MARICOPA COUNTY
Department of Transportation

MEMORANDUM

Subject: Miscellaneous Corrections **Case 15-01A**

Subject: Miscellaneous Corrections **Case 15-01 D**

DETAIL NO.				REVISED	DETAIL NO.
225	MARICOPA ASSOCIATION of GOVERNMENTS STANDARD DETAIL ENGLISH	CONCRETE PAVERS		01-01-2016	225

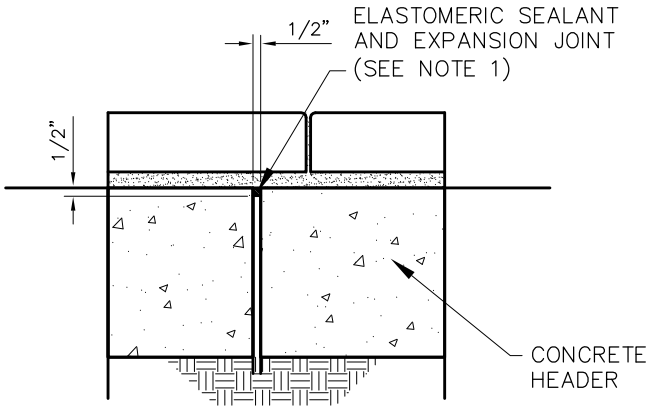
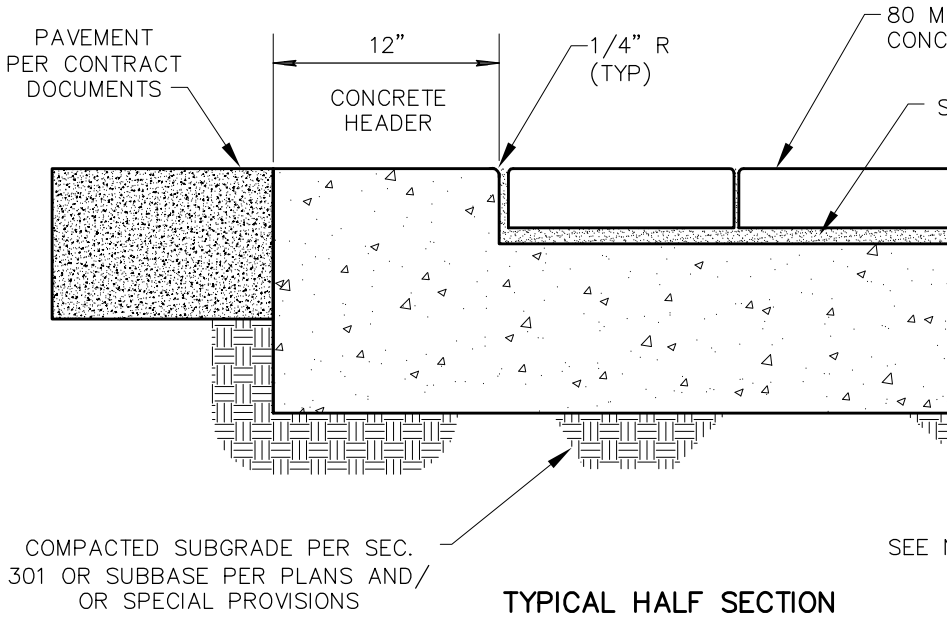
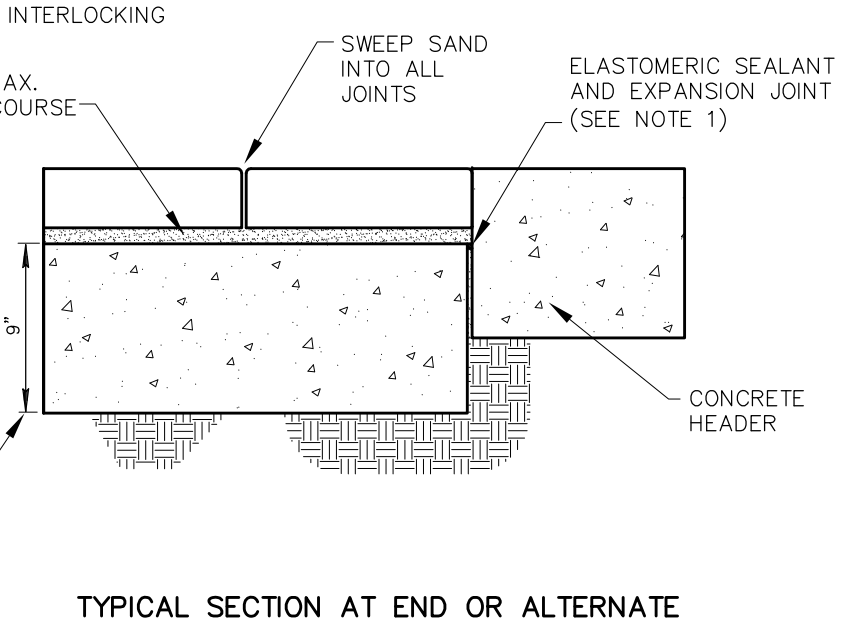
REVISE 'QA', TO QUALITY ASSURANCE
" 'QC', " " CONTROL

THE DEFINITIONS OF QA AND QC HAVE NOT BEEN IDENTIFIED.

DETAIL NO.			REVISED	DETAIL NO.
270	MARICOPA ASSOCIATION of GOVERNMENTS — STANDARD DETAIL ENGLISH	FRAME AND COVER AND GRADE ADJUSTMENT	01-01-2016	270

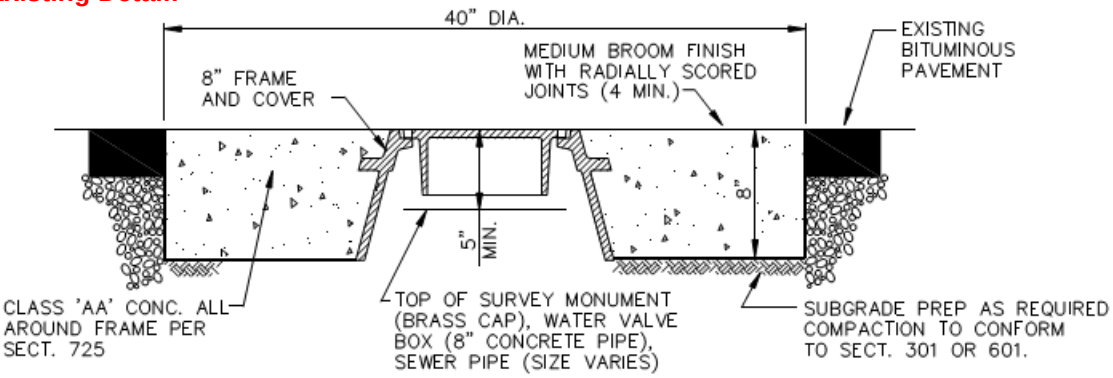
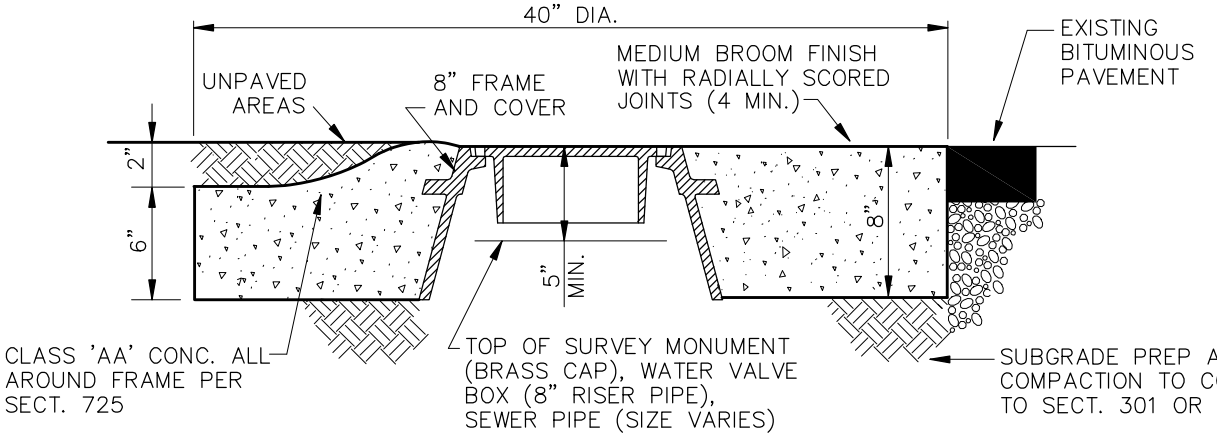
Correction 2 – Revise the grade adjustment detail.
Revise the title, show both paved and unpaved conditions, and replace (8" CONCRETE PIPE) with (8" RISER PIPE).

Revised Title: GRADE ADJUSTMENT FOR FRAME AND COVER

GRADE ADJUSTMENT FOR FRAME AND COVER
